Enclosure 1

Concerns Regarding Thermal Shield

At SONGS 1

Figure OC-4-1

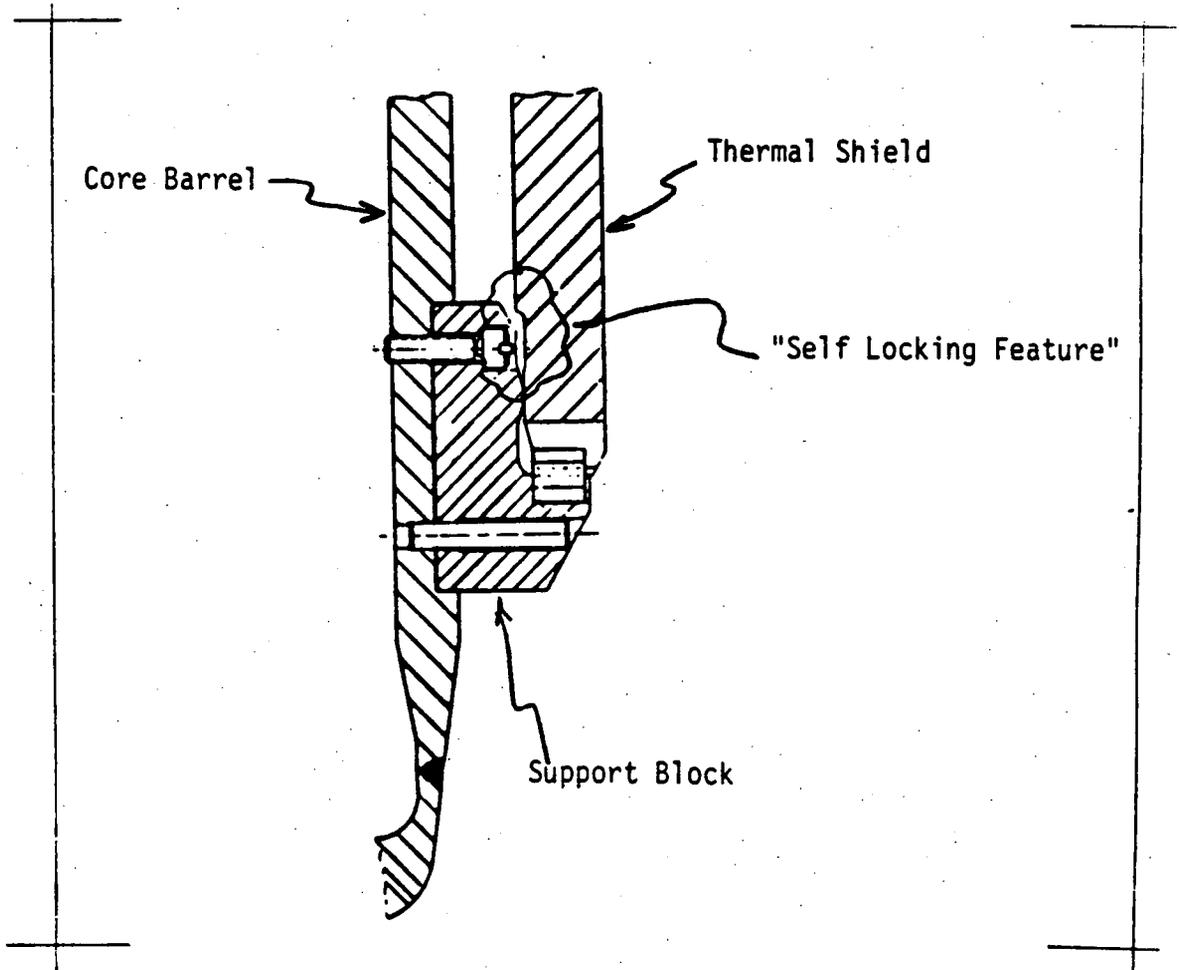
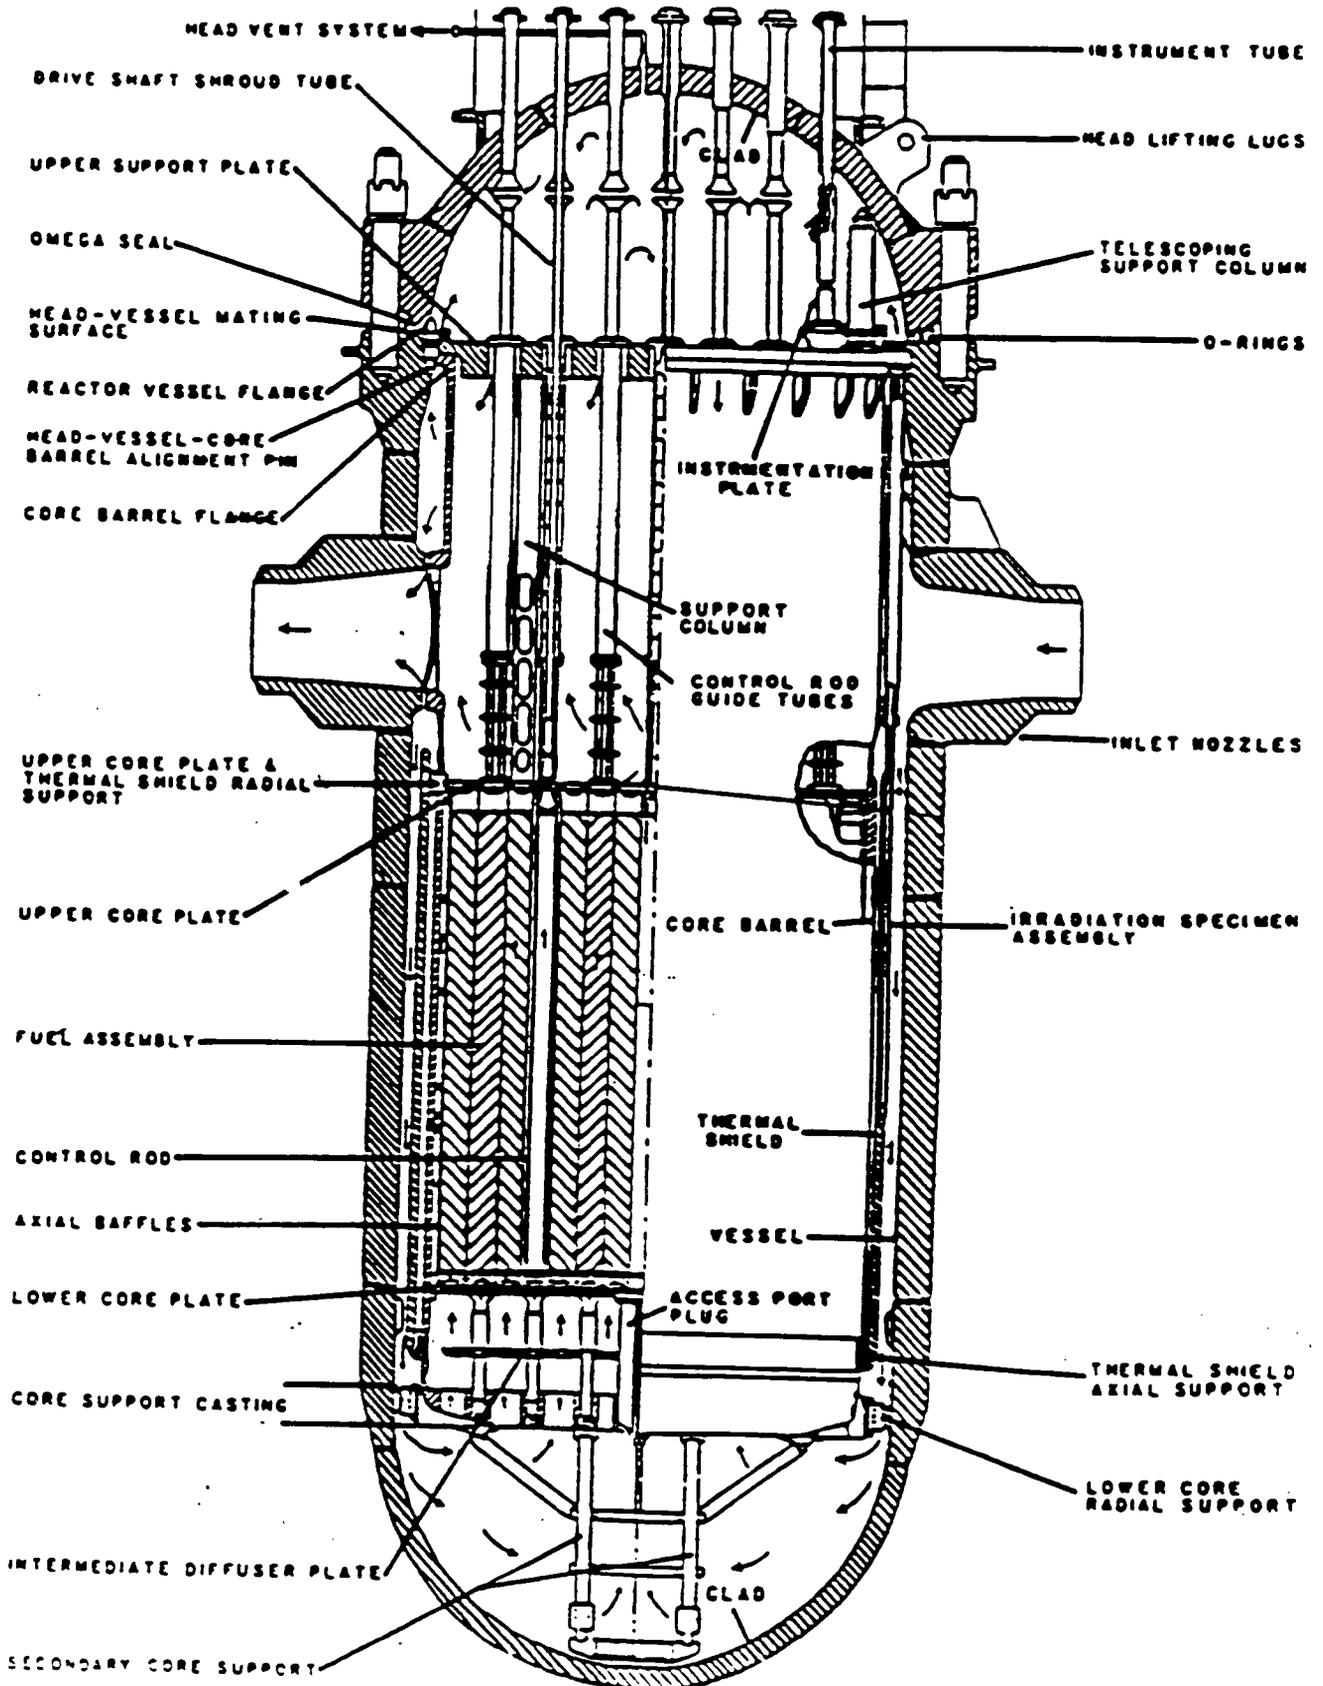
- OC-4. "In view of uncertainty regarding the bolts of the support blocks there is a possibility that as a result of vibration of the thermal shield the support blocks may slip out from their positions. In the worst case the thermal shield could drop to the bottom of the reactor vessel."

The "uncertainty" regarding the bolts has been addressed in the response to the second concern. As documented in Section 7.0, "Consequences of Further Degradation," of WCAP 12148 (Reference 1), analyses were performed which demonstrate that safe operation can be maintained even with the worst credible degraded condition of the thermal shield supports. Even if all the bolts were to fail, the possibility that one or more blocks could slip out of position is essentially non-existent because of the design features which are discussed in Section 7.0, "Expected Support Block Degradation," and 7.1, "Definition/Evaluation of Worst Possible Degraded Cases," of WCAP 12148. Figure OC-4-1 shows the design also includes a self-locking feature which supports the thermal shield if the block ledge on which the shield rests is fractured or worn away. While there is no credible scenario for failure of this ledge, the design provides for this postulated condition. The analyses of the worst credible degraded condition which are documented in the subsequent sections of WCAP 12148 provide further confirmation the thermal shield will remain in-place and in a dynamically stable condition. The ultimate conclusion of the various analyses, including the seismic analysis is that the thermal shield will remain in-place even if all the bolts are broken.

In addition, if all the blocks were to non-mechanistically fail or come out of position, analysis has shown in Section 9.2, "Thermal Shield Drop Analysis," of WCAP 12148 the lower radial support keys can withstand the resulting impact of the thermal shield without exceeding stress limits. These lower radial support keys are located well above the bottom of the vessel (11 inches total drop) and the total flow in the downcomer would not be significantly reduced (see Figure OC-4-2). It was also shown that if the shield did drop onto the lower radial supports, there would be no adverse effect on normal operating reactor core limits, nor the consequences of design basis accidents.

In conclusion, analyses and evaluations have been performed which demonstrate that the thermal shield dropping to the bottom of the reactor vessel is not credible.

Figure SC-1-1

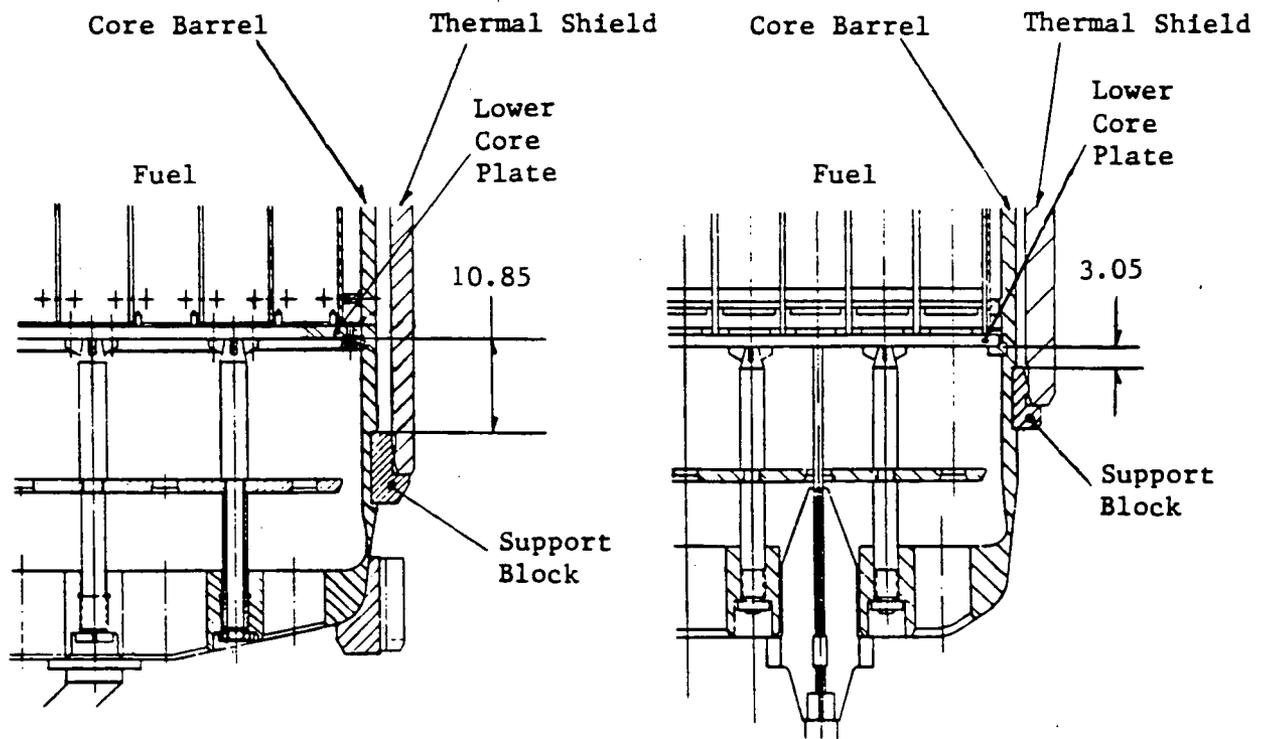
SC-1a. "Why was loss of bolt preload from radiation-assisted relaxation not considered?"

As shown in Figure SC-1-1, the lower support blocks at Haddam Neck are approximately 3 inches below the lower core plate and blocks at SONGS 1 are approximately 11 inches below the lower core plate. Also, the Haddam Neck plant has been in operation longer than SONGS 1 (15 effective full power years vs. 11 effective full power years). Considering the above, it is probable that the SONGS 1 lower support blocks have been exposed to less radiation than the Haddam Neck lower support bolts. Therefore, it is concluded that the SONGS 1 lower support bolts have been affected very little by irradiation, therefore radiation-assisted relaxation is not considered. However, the bolt preload was reduced by 12% to account for thermal stress relaxation in the temperature range of 500°F to 700°F.

FIGURE SC-1-2

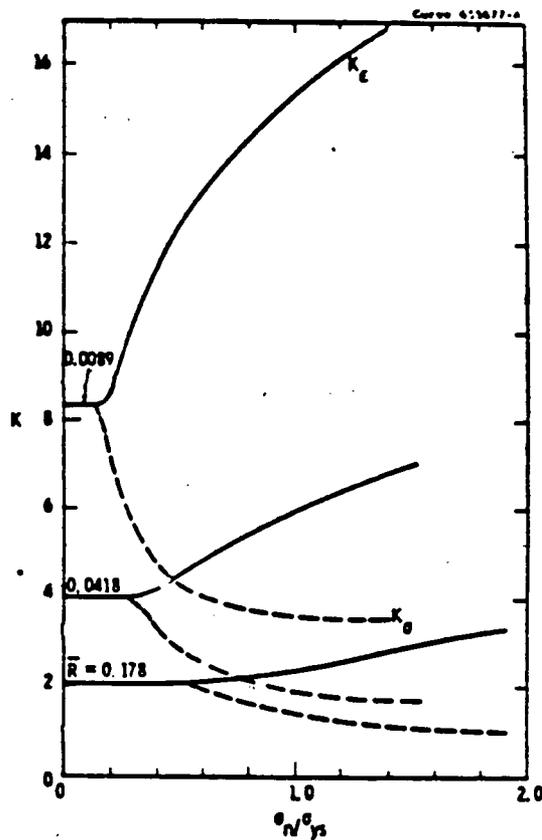
SC-1e. "NB-3232.3(c) recommends use of a fatigue strength reduction value of not less than 4.0. Justify use of a smaller value.

An elastic concentration factor of 4.0 was used at the threads for tension and this value is based on the ASME Boiler & Pressure Vessel Code Section III paragraph NG-3232.3(c). For bending, the elastic concentration factor used was 3.5. This is based on a comparison of concentration factors for a grooved shaft ("Peterson," Figures 31 and 49) where a 4.0 factor in tension corresponds to a 3.5 factor in bending for the same geometry.

When the material is cycling in the elastic range, a notch sensitivity factor can be used to lower the concentration factor. In the case of the 316 SS bolts, a material notch sensitivity factor of $q = .6$ is applicable. The resulting fatigue notched reduction factor K_f , is determined by:

Figure SC-2-1

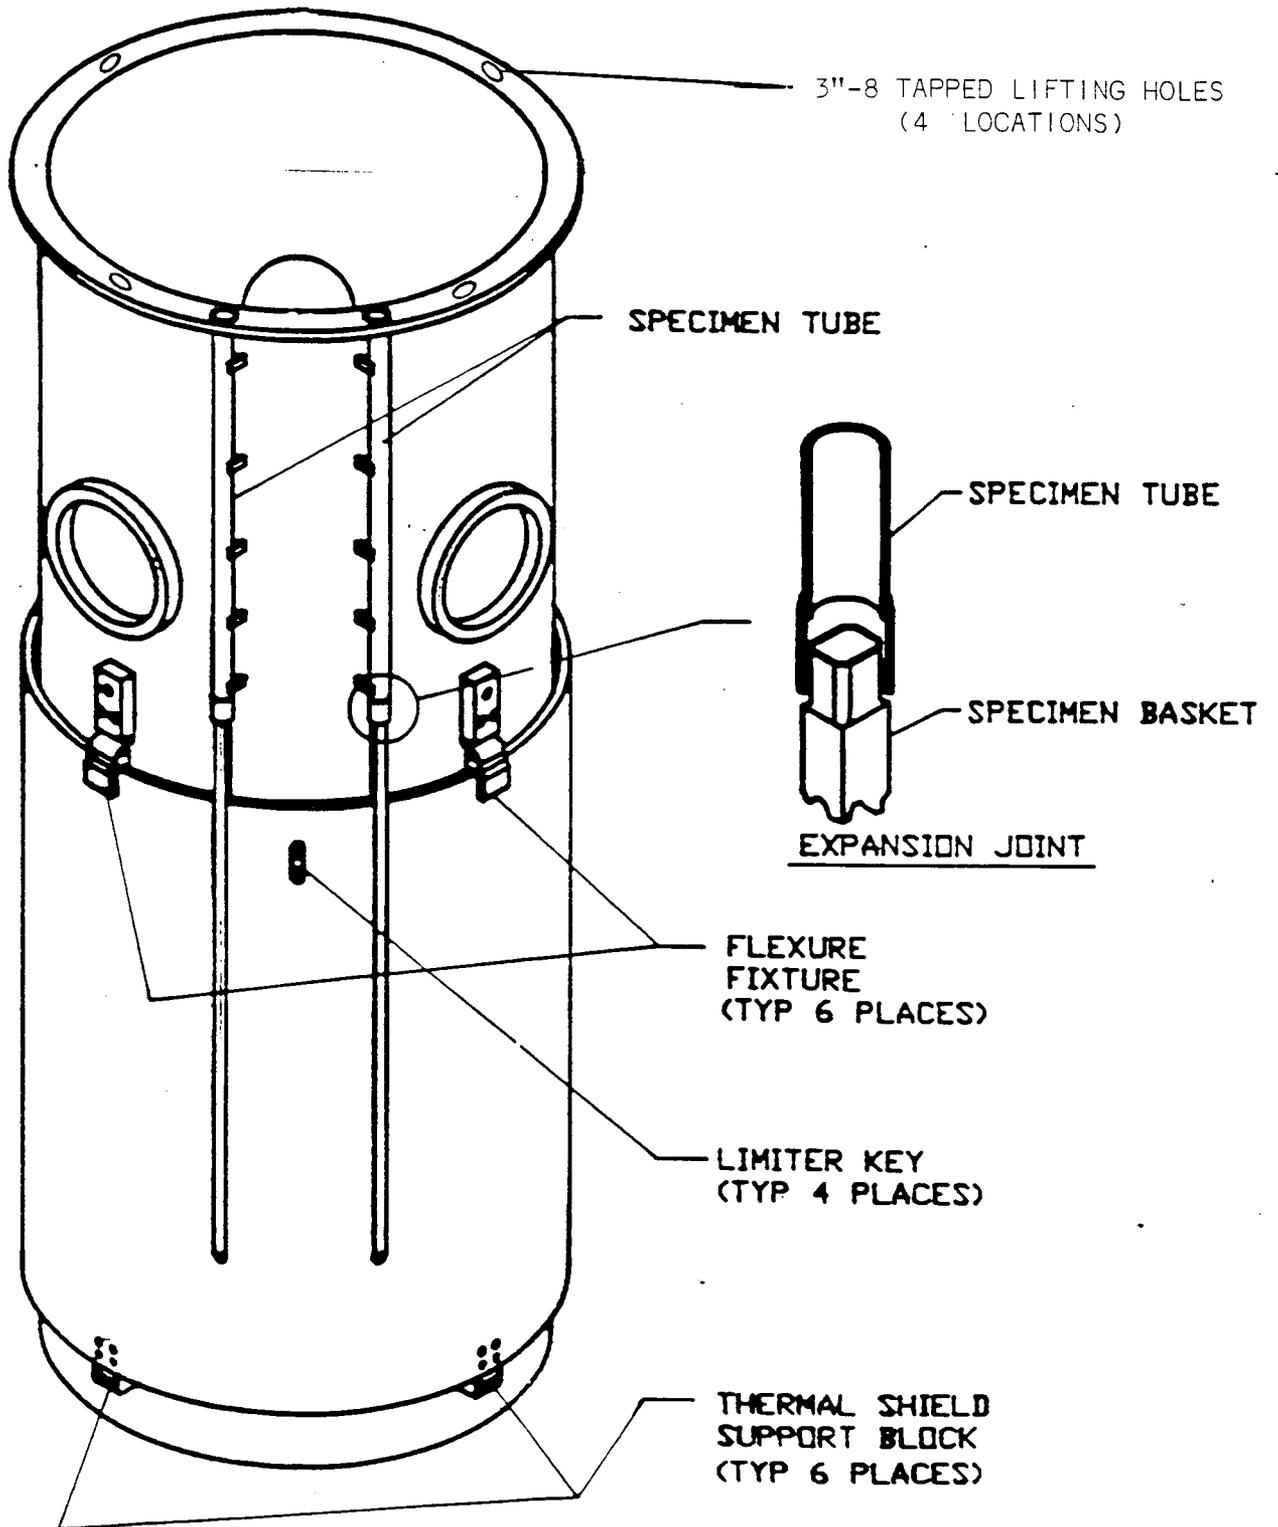
"By using a different camera system or removing more fuel assemblies could: (a) additional surfaces of the components be inspected or (b) additional access be provided to the lower thermal shield support blocks, the limiter keys, or the core barrel radial support keys?"

As explained below, removing additional fuel would not have enhanced accessibility for the camera system. The camera and supporting systems utilized was evaluated superior to other systems in accessibility, picture quality and proven performance in a high radiation environment.
